December 17, 2021

Re: Phillips 66 – Application No. B0241 for Three Low-Carbon Fuel Standard Tier 2 Fuel Pathways

Communities for a Better Environment and the Natural Resources Defense Council (“Commenters”) offer the following comments on the Low Carbon Fuel Standard (“LCFS”) Tier 2 Pathway Application No. B0241 submitted by Phillips 66.

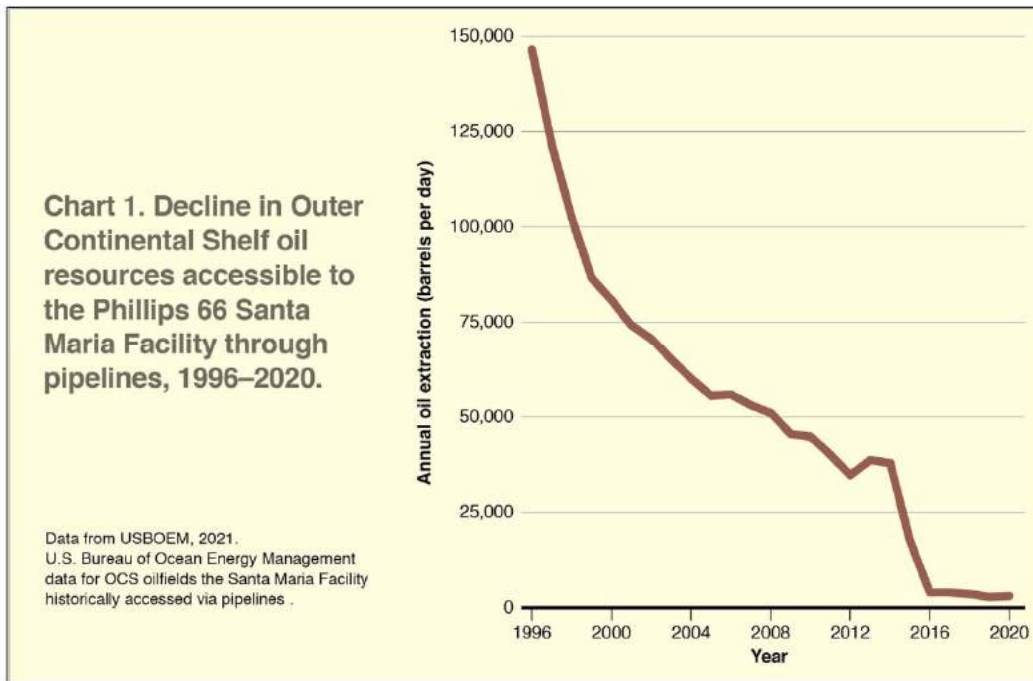
In 2014 San Luis Obispo County conducted the type of crude access limitation review for the Santa Maria facility that found steeply declining crude feedstock availability. This review was referenced in the Scoping Comments but ignored by the County. It should not have been, because it is pertinent to the question of baseline and clearly undercuts the DEIR's conclusion regarding it. It should hence have been disclosed and addressed in the DEIR – especially given that (as discussed below and above), constraints have only gotten more severe in the intervening years. San Luis Obispo County found that as of 2014, the facility's continuing crude supply was already in doubt:

Having only one pipeline system available for delivering crude oil to the refinery limits the [Santa Maria facility] refinery's ability to obtain crude oil from sources outside the local area. ... In the long-term, the need [for the Santa Maria facility to access new sources of crude] could be driven by declines in local production of crude oil that can be delivered by pipeline. Production from offshore ... (OCS crude) has been in decline for a number of years. Oil production in Santa Barbara County (both onshore and offshore) peaked at about 188,000 barrels in 1995 ...

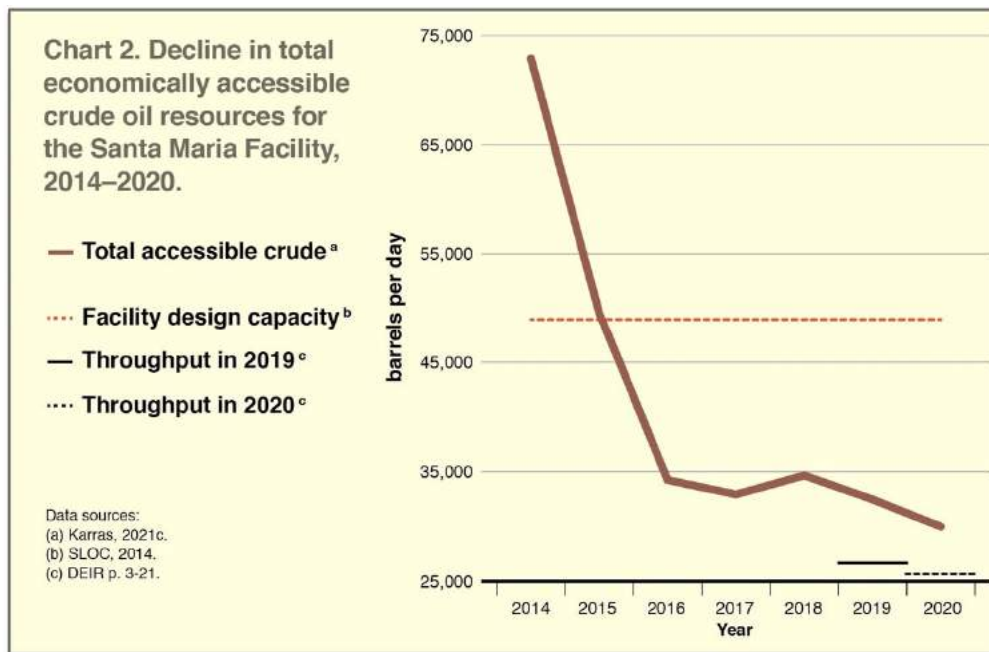
The BOEM data illustrated in Chart 1 indicate that crude production from OCS oilfields that the Santa Maria facility has historically been able to access continued in steep long-term decline after the 2014 San Luis Obispo analysis. From an annual average of approximately 146,000 barrels per day (b/d) in 1996, OCS oil production from these fields,⁶⁷ collectively, fell by 98% to approximately 3,000 b/d in 2020.⁶⁸ Had the DEIR disclosed these data, the County could and should have found that the historically dominant OCS source of crude refined by the Santa Maria facility is in steep terminal decline; and hence that a baseline grounded in assumptions of historic production levels is unsupportable.

5.1.1 The DEIR baseline analysis provides an incomplete, inaccurate and misleading description of the unique physical SFC configuration, its unique geographic setting, and its resultant limited access to petroleum resources for refinery feedstock

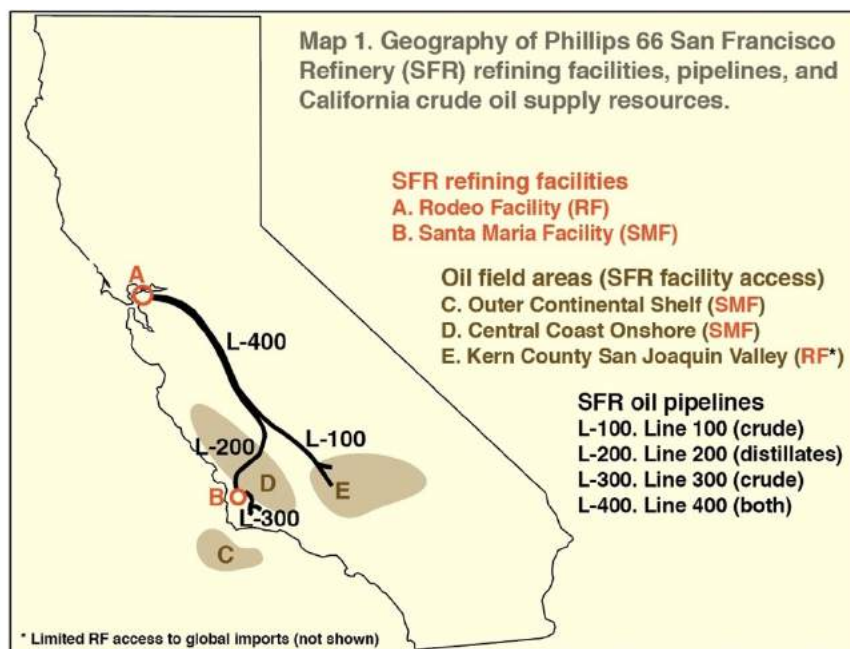
The DEIR does not disclose, evaluate, or accurately describe the functional interdependence of SFC components, their unique geography, and the resultant unique limitations in accessible crude feedstock for the SFC. Map 1 illustrates the unique geographic distribution of SFC components in relation to the landlocked crude resources that the SFC was uniquely designed to access for feedstock.¹⁵⁸ The Rodeo Refining Facility (RF) of the SFC (“A” in Map 1) receives most of its oil feed as crude from San Joaquin Valley oilfields (“E”) that is blended with, and crucially, thinned by, oils processed in its Santa Maria Refining Facility (SMF) (“B”) from crude that its pipeline system collects from offshore (“C”) and onshore (“D”) Central Coast oilfields.
